Addendum 134 – UN Regulation No. 135

Revision 1 - Amendment 2

Supplement 2 to the 01 series of amendments – Date of entry into force: 29 May 2020

Uniform provisions concerning the approval of vehicles with regard to their Pole Side Impact performance (PSI)

Figure

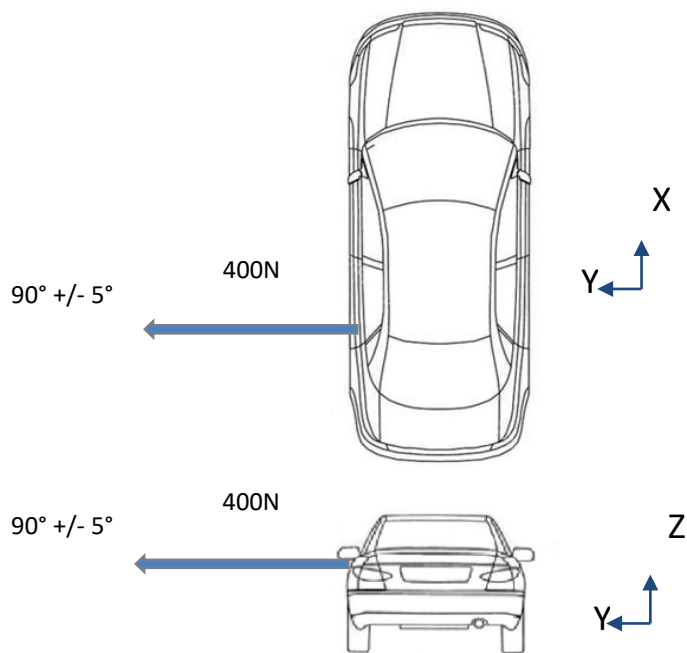
Paragraph 5.4.2.1, amend to read:

"5.4.2.1. The door shall remain latched;

This requirement is deemed to be fulfilled:

- (a) If it is clearly visible, that the door lock is latched; or
- (b) If the door does not open under a static tractive force of at least 400 N in the y-direction applied to the door, according to the Figure below, as close as possible to the window sill and to the edge of the door opposite to the hinged side, except to the door handle itself.
